# REQUEST FOR MULHOLLAND SCENIC PARKWAY SPECIFIC PLAN

8414 EDWIN DRIVE

MULHOLLAND SCENIC PARKWAY SPECIFIC PLAN DESIGN REVIEW BOARD

RESPONSE TO DESIGN REVIEW COMMENTS

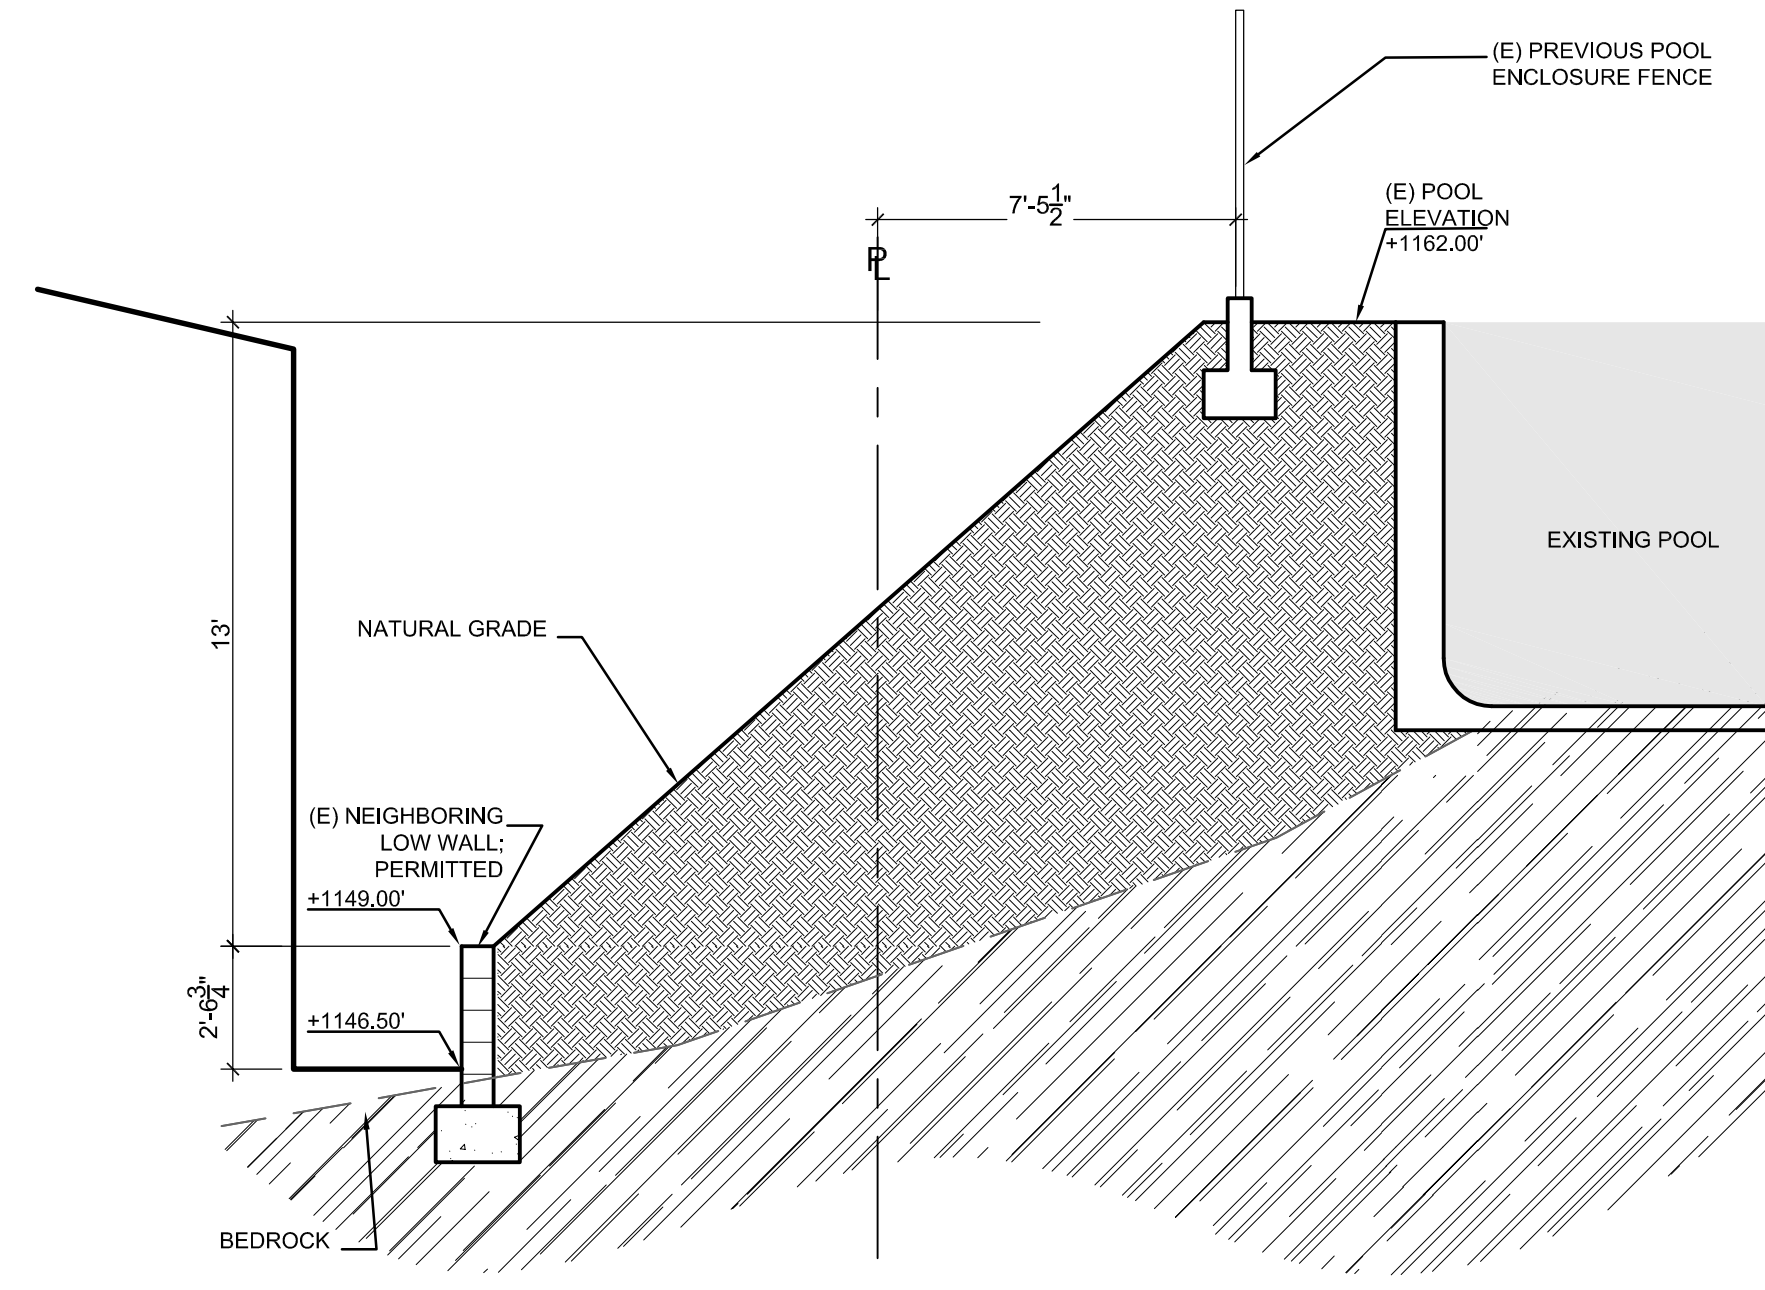
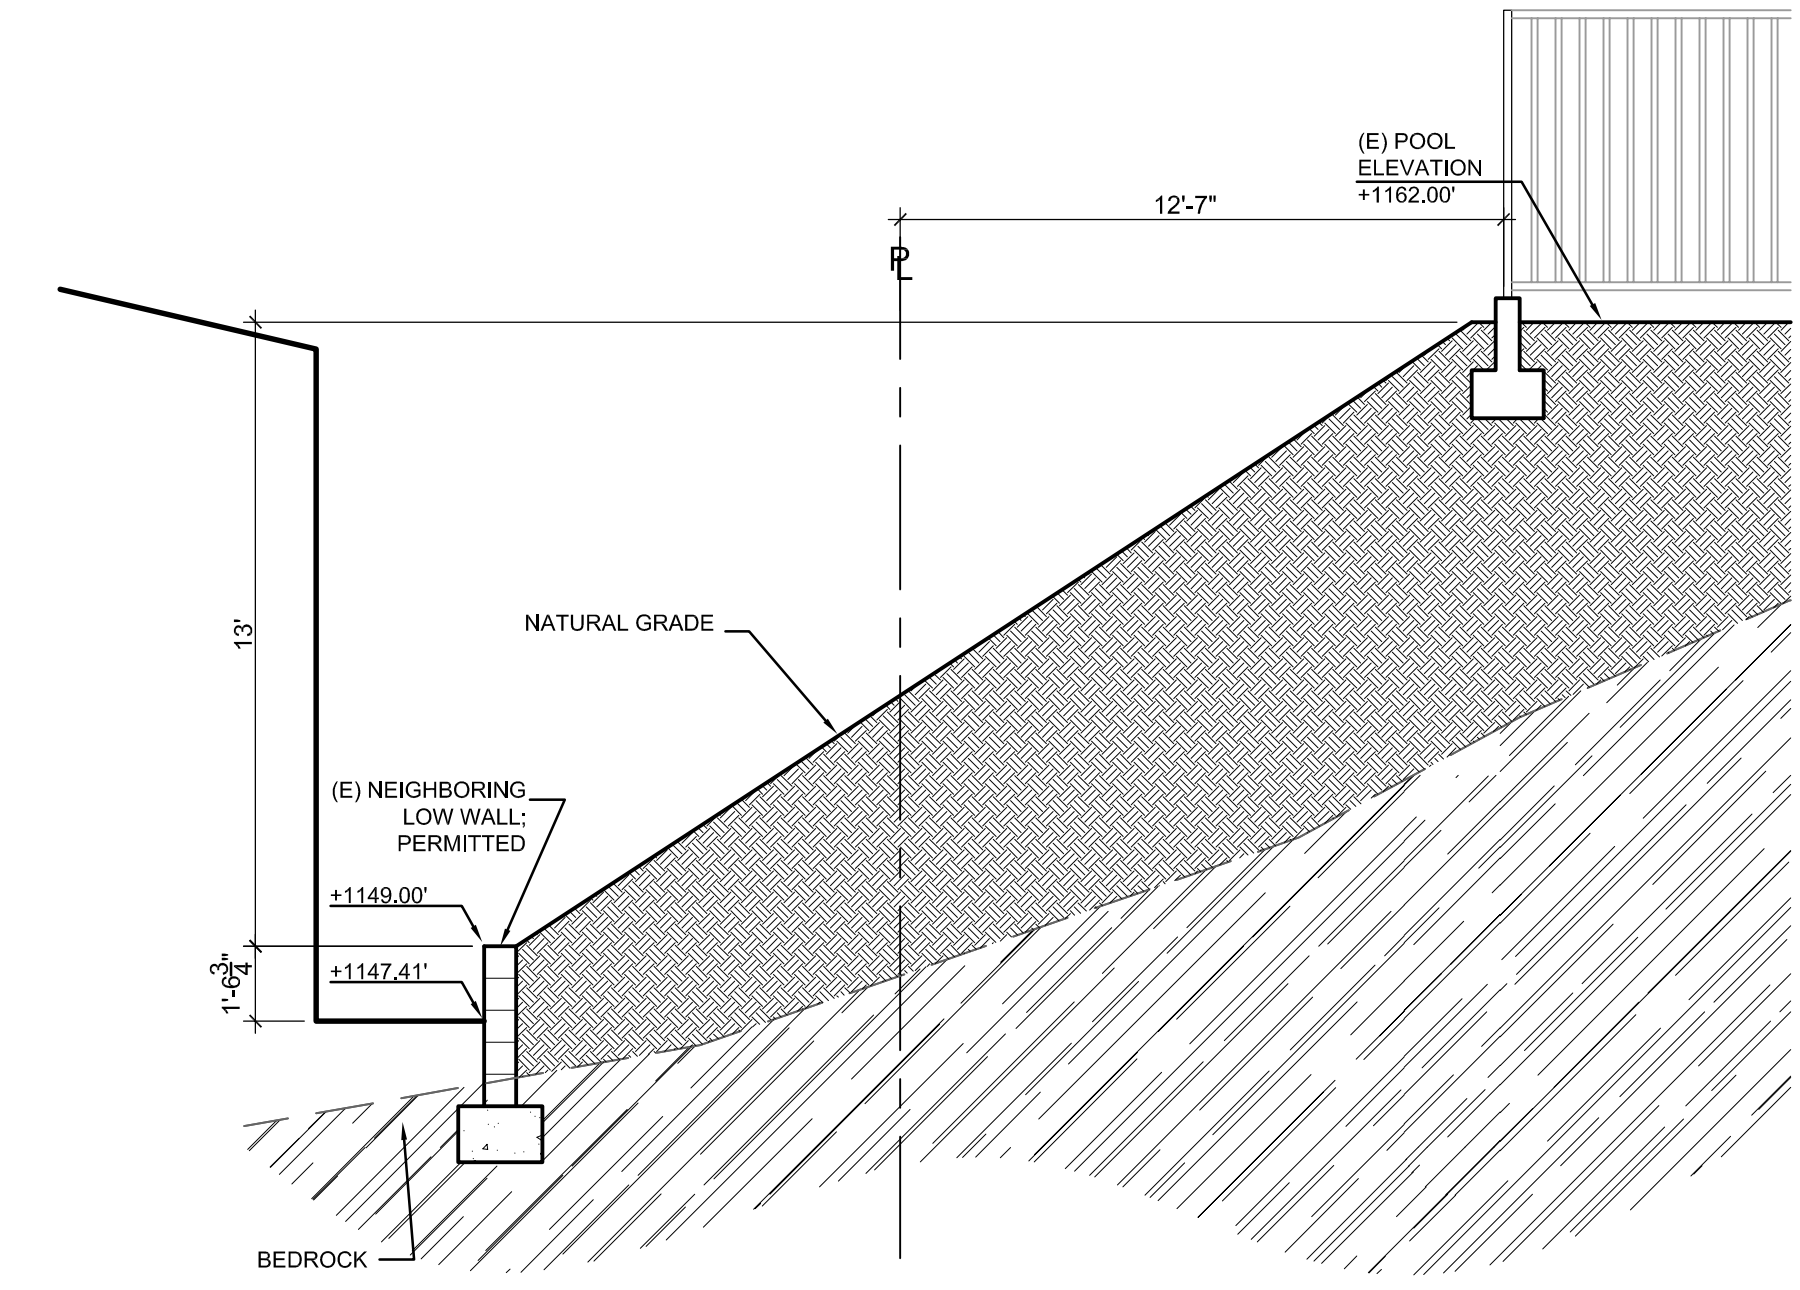
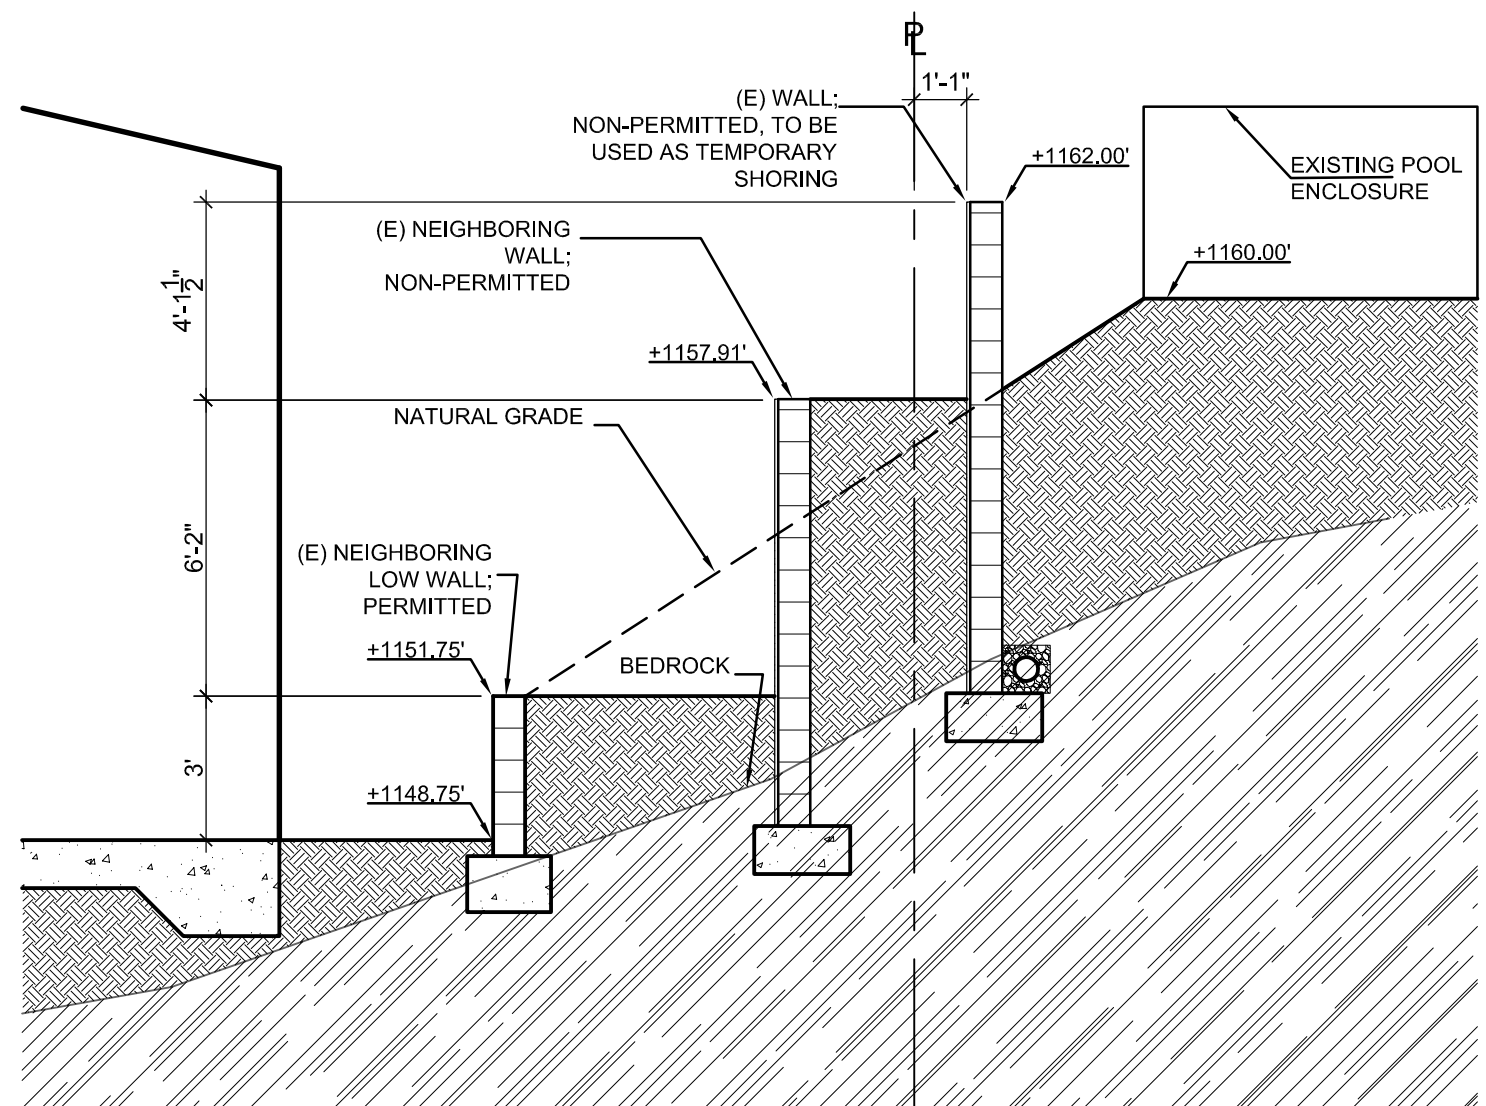
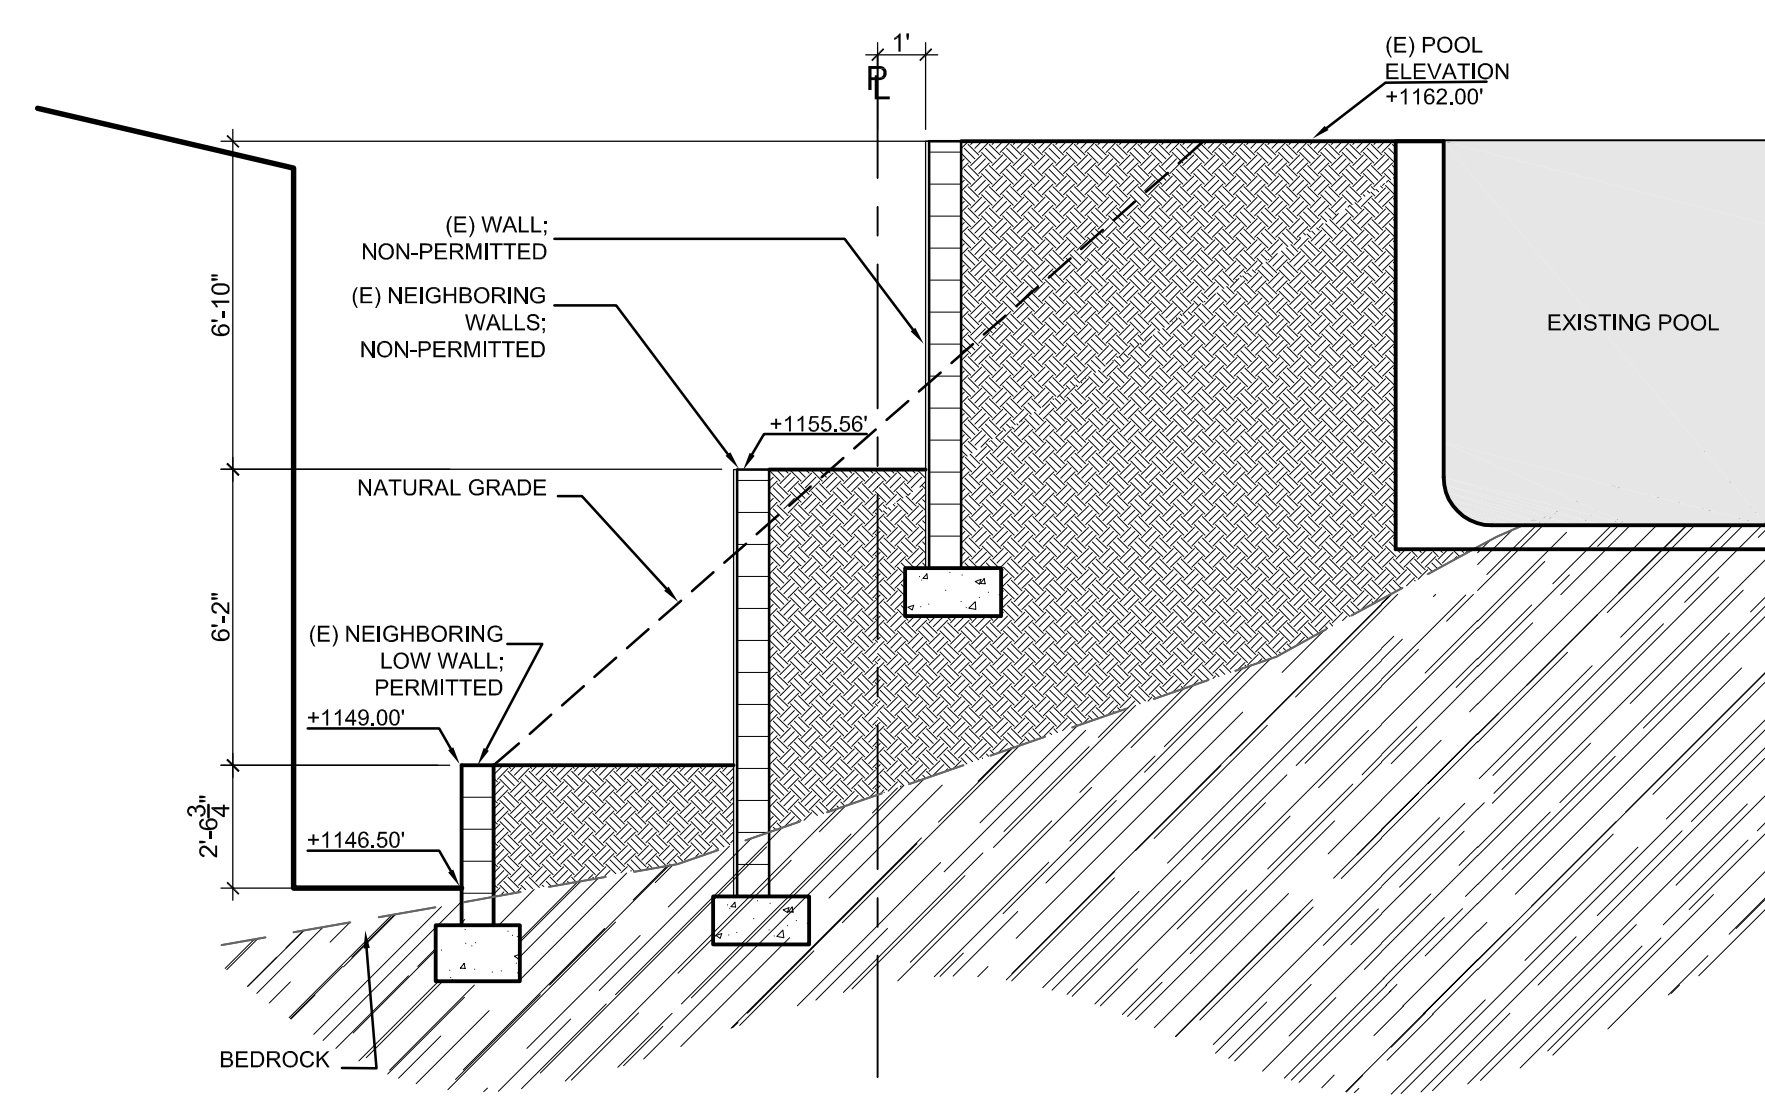
- Show 3 sections: prior, existing, and proposed of wall at property line for a total of 9 drawings like those sections shown on pg. 28

The major concern from the Design Review Board was making sure the project retaining wall design is "independent" downhill to the adjacent neighboring property. In order to ensure safety, we are designing retaining walls, by-right, using LADBS regulations, zoning code, and the Mulholland Specific Plan. Major caisson construction will allow all grade levels located at 8414 Edwin Drive to remain independent of the adjacent site and street level.

- 1 THE NINE NEW SECTIONS ON PAGE 28A ILLUSTRATE OUR PROPOSITION CONFORMING TO THE SPECIFIC PLAN GUIDELINES WHILE RETAINING INDEPENDENCE BETWEEN OUR SITE AND ANY NEIGHBOING PROPERTIES.
- 2 ANY NEW RETAINING WALLS WILL BE CONCEALED BY DENSE PLANTING, INCLUDING TREES, SHRUBS, AND VINES AS PER OUR PROJECT RENDERS ON PAGE 23 AND LANDSCAPE DRAWINGS
- 3 OUR NEW PLANT LIST CONSISTS OF AT LEAST 75% PREFERRED PLANTS.
- 4 SECTIONS ON PAGE 28A CONFIRM THAT NEW RETAINING WALLS DO NOT EXCEED 10 FEET IN HEIGHT AND CONFORM TO THE GUIDELINES OF THE SPECIFIC PLAN.
